**August 1, 2014**  
**BOARD OF COUNTY COMMISSIONERS**  
**ORANGE COUNTY, FLORIDA**

**ADDENDUM NO. 4**  
**IFB NO. Y14-748**  
**ORANGE COUNTY EASTERN WATER RECLAMATION FACILITY**  
**PHASE V AND CENTRIFUGE DEWATERING IMPROVEMENTS**

**C-121**  
33 OF 527

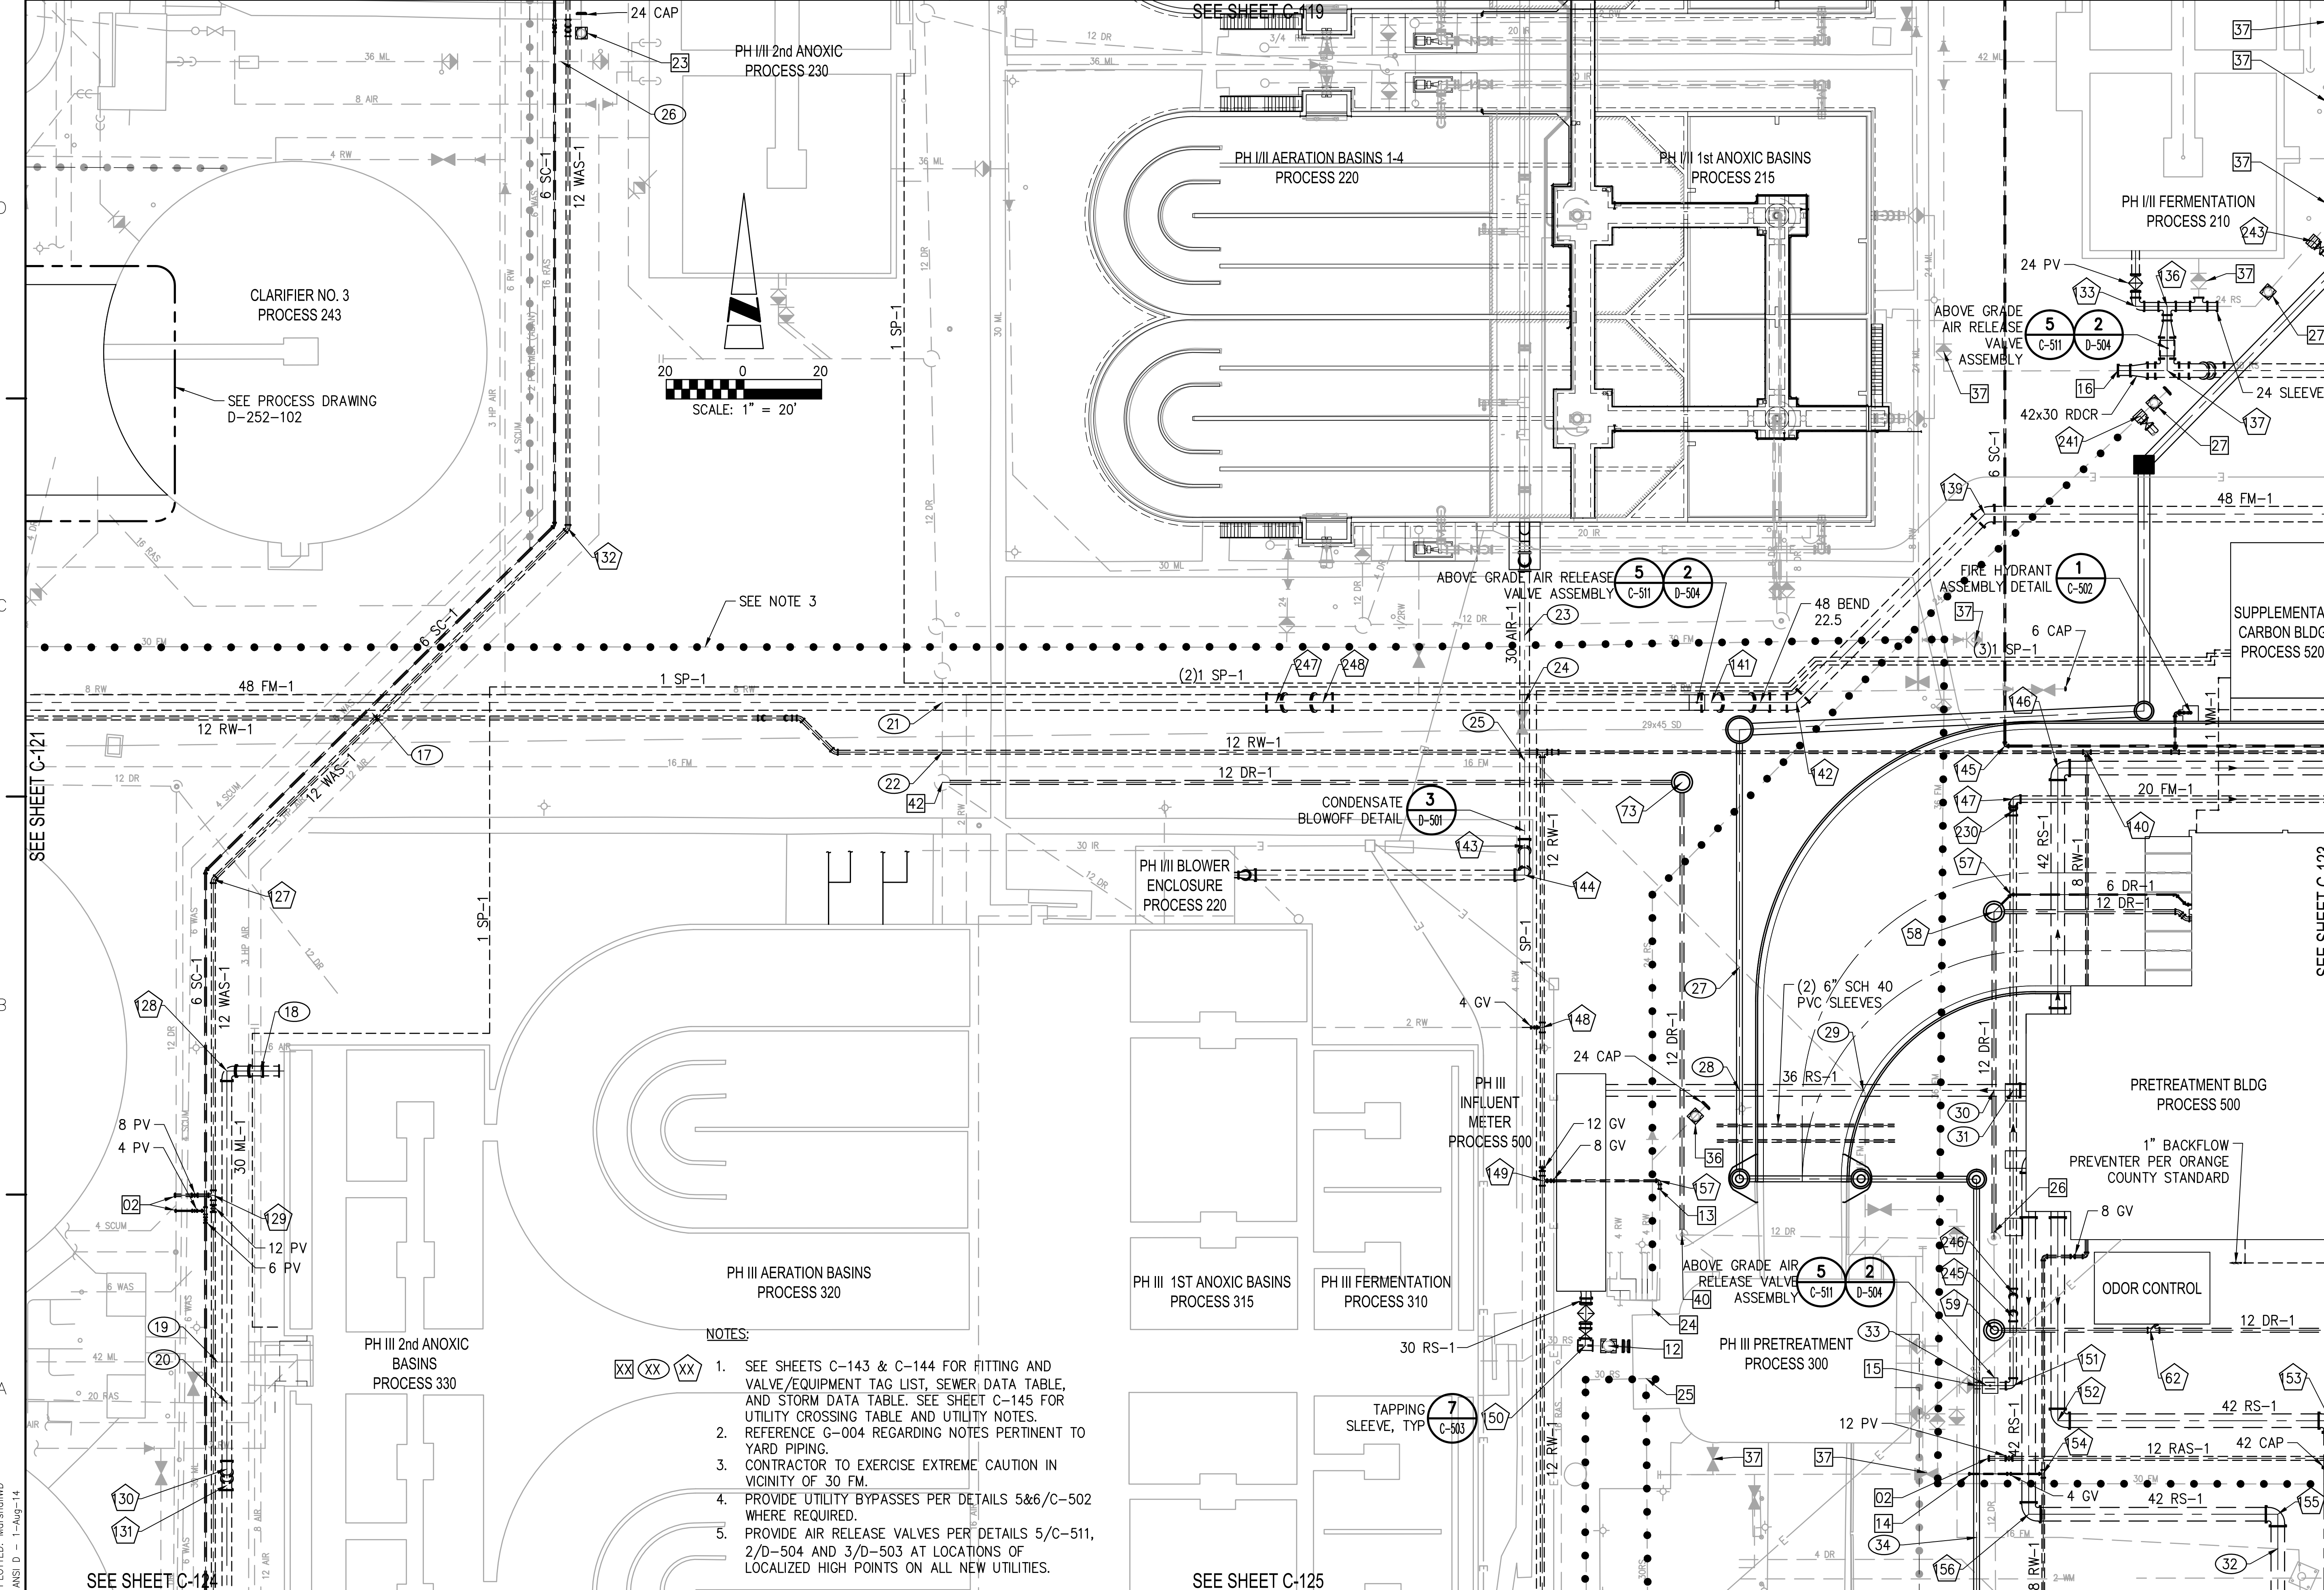
18. Refer to Bid Package A. Reference Drawing C-121. Drawing calls out for a 20x16 wet tap with valve, Tag No. 118; however both lines are 20" in size. Please clarify.

19. Refer to Bid Package A. Reference Drawing C-121. Drawing calls out for 42x30 wet tap with valve, Tag No. 123, however both lines are 42" in size. Please clarify.

88. Reference Bid Package A, Drawing C-121 - Please confirm that the unidentified valve At Wet Tap 236 located on the RW-1 Line, sheet C-121 is in fact required for this project (redundant?), and that it is a plug valve.

91. Reference Bid Package A, Drawing C-121 - Please confirm that the unidentified valve At Wet Tap 123 located on the SE-1 Line, sheet C-121 is in fact required for this project (redundant?), and that it is a plug valve.

92. Reference Bid Package A, Drawing C-121 - Please confirm that the unidentified valve At Wet Tap 118 located on the SE-1 Line, sheet C-121 is in fact required for this project (redundant?), and that it is a plug valve.

*The additional plug valve is not required in this location. Drawing C-121 is revised to eliminate that 12" plug valve at Fitting No. 236 (**Attachment**).*

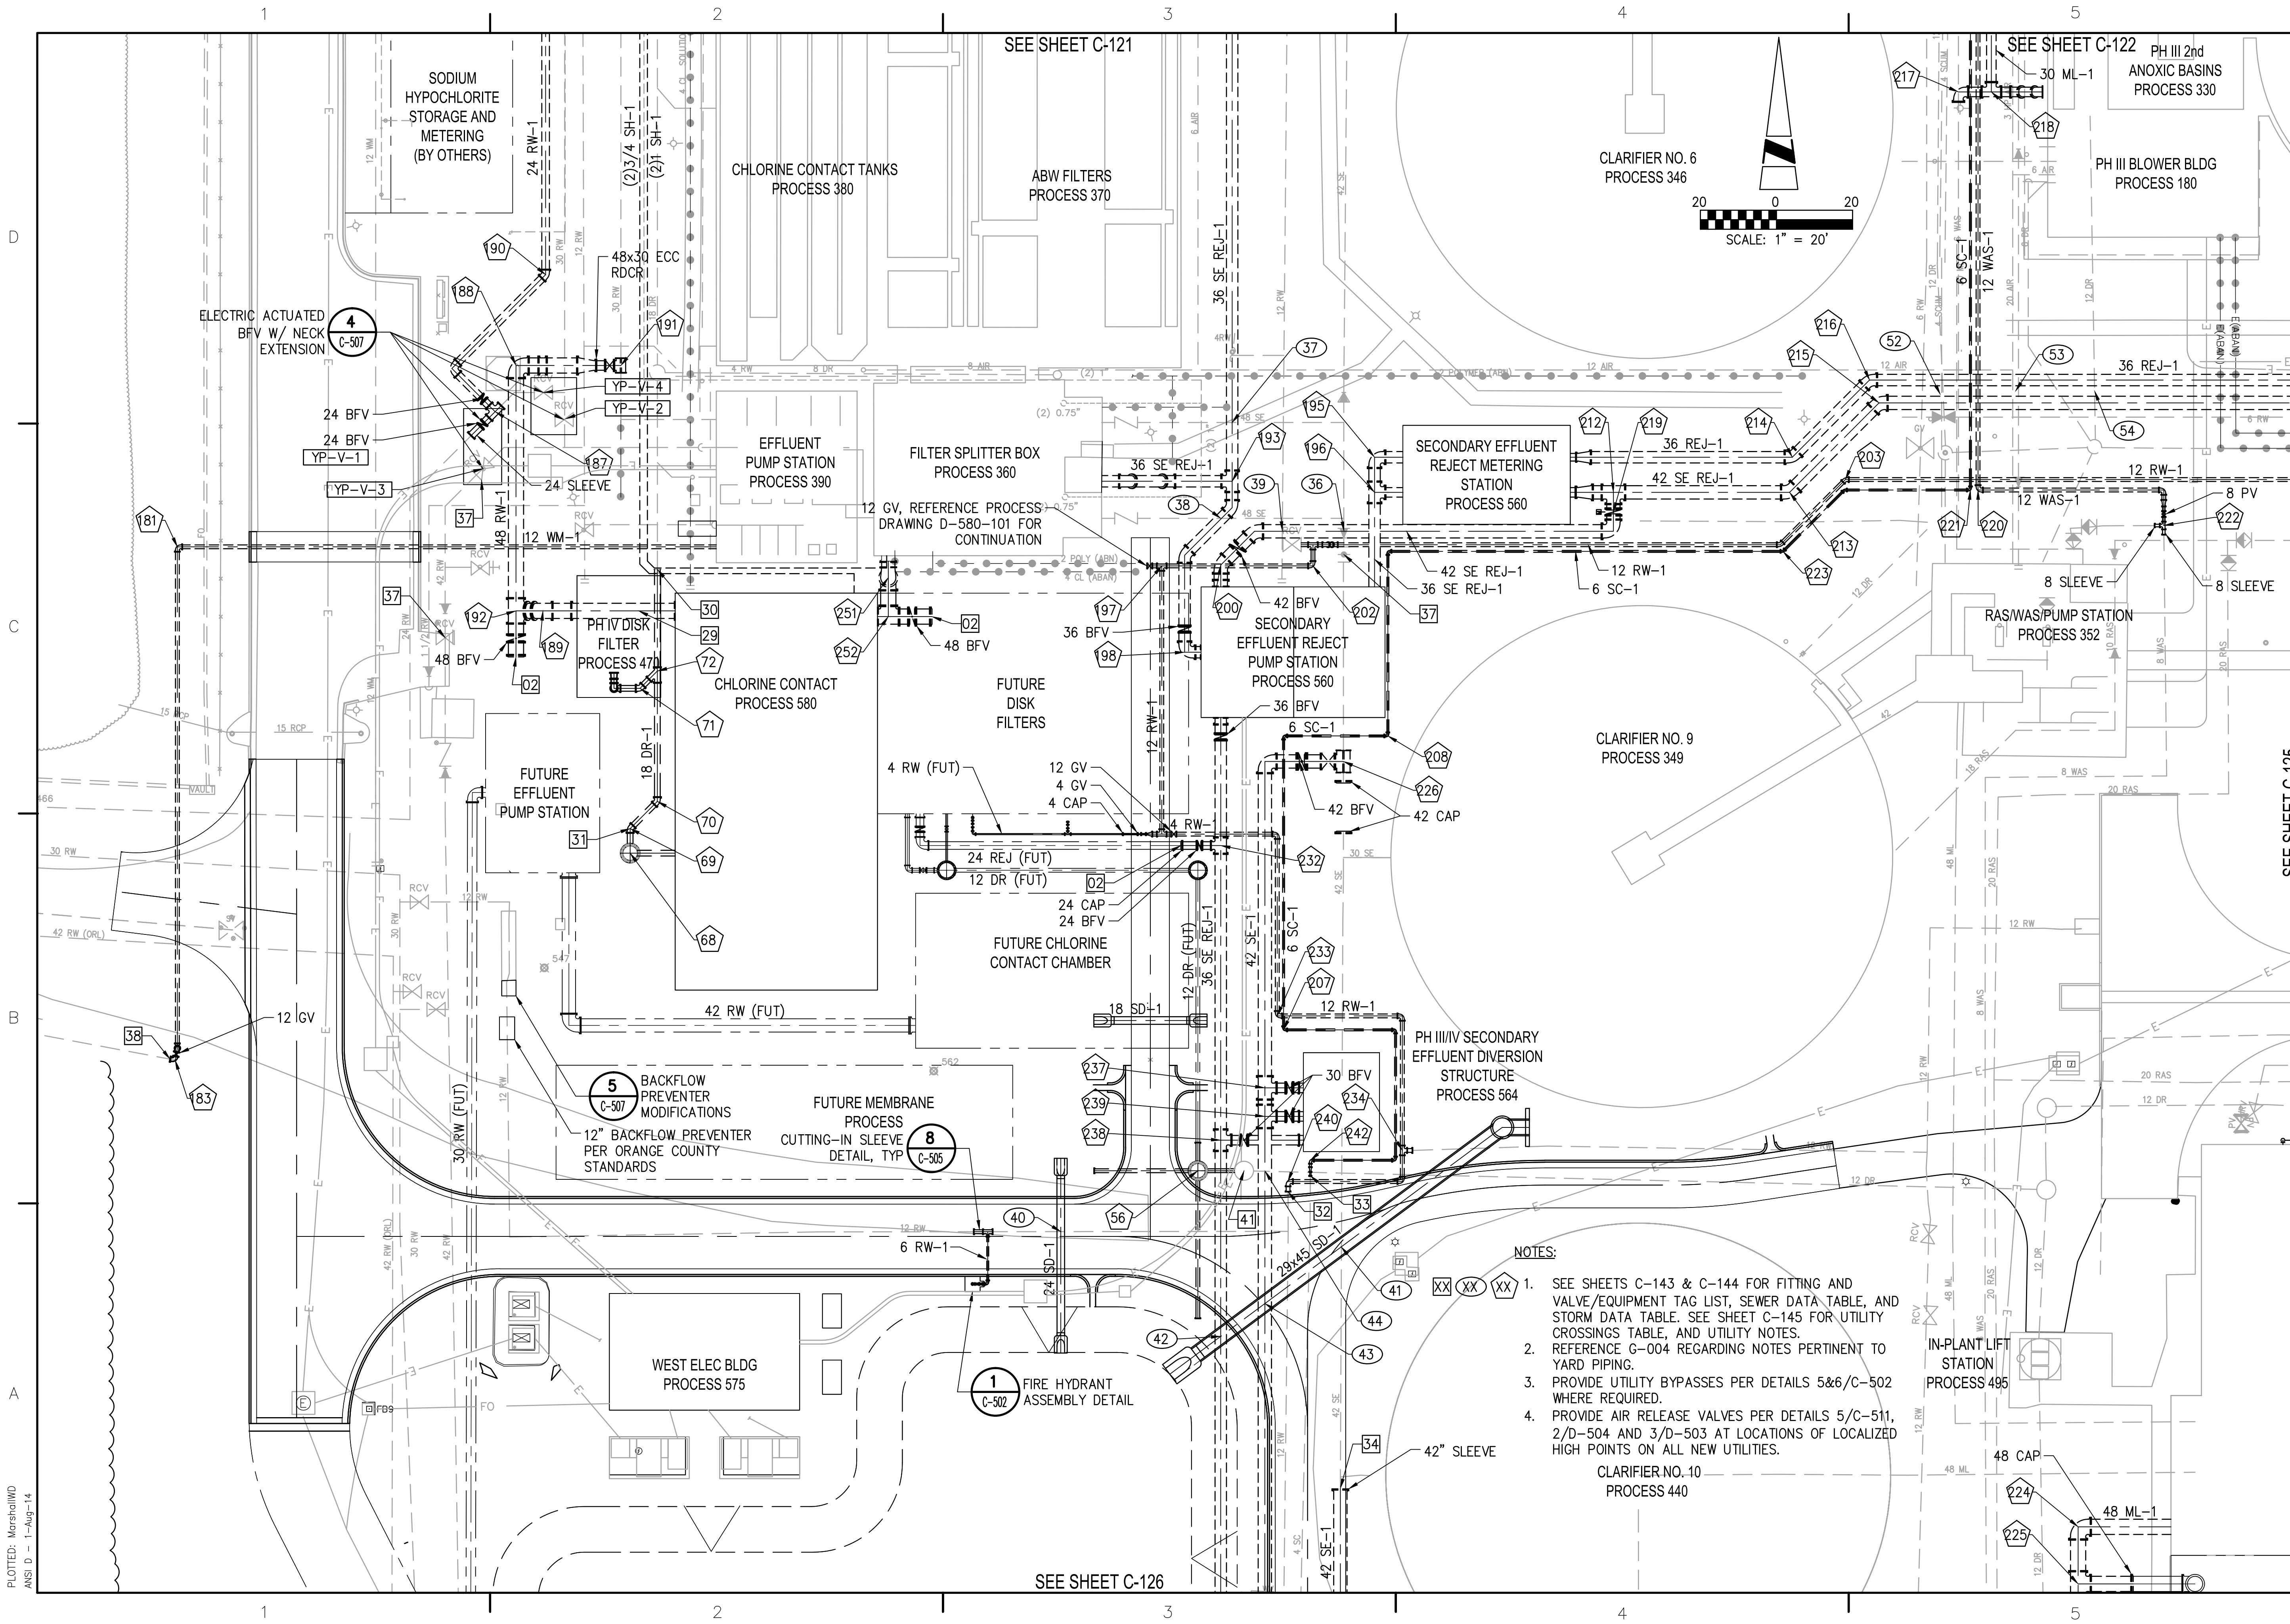
14. Refer to Bid Package A. Reference Drawing C-124. Drawing indicates electric actuated BFV YP-V-4 to existing, however the valve schedule (Specification Section 15119-10) indicates the valve to be new. Please clarify.

86. Reference Bid Package A, Drawing C-124 - Please confirm that the unidentified valve east of the 42"x42" Wet Tap for the SE-1 line located on sheet C-124 is in fact required for this project (redundant?), and that it is a plug valve.

87. Reference Bid Package A, Drawing C-124 - The 24" Gate Valve Southeast of the Future Disk Filters on sheet C-124 located on the SE REJ-1 Line is depicted as a Butterfly Valve, please confirm that this valve is a Butterfly Valve and not a Gate Valve as called out on the plans.

90. Reference Bid Package A, Drawing C-124 - RW-1 – There is a note that says, Reference Process Drawings for Continuation; however Process 360 and 580 have no reference to this line. Sheet D-560-100 has no detail either. Please detail the tie-in, or continuance of this line.

*A plug valve was shown on C-124, zone C3 to the west of the 42X42 hot tap at callout 226. Reference Drawing C-124 revising this valve to be a butterfly valve (**Attachment**).*

*Correct, the butterfly valve was shown on C-124, zone B3 to the west of the 36X24 tee at callout 232. Reference Drawing C-124 revising this callout to be a 24 BFV (**Attachment**).*

*Please reference Bid Package A, Drawing D-580-101 for the continuation of the 12 RW-1 utility to the pump station Drawing D-390-102. The note on Drawing C-124, zone C3 is revised to reflect this and identify the 12" gate valve at the 12" tee, fitting identification tag 197 (**Attachment**).*

*Reference Bid Package A, Specification Section 15119, Electric Motorized Actuators and Drawing C-124. Refer to Addendum 4, Bidder Question 14. Valves YP-V-2, 3 & 4 are existing. Contractor shall retrofit valves with electric motor actuators and not replace the valves.*
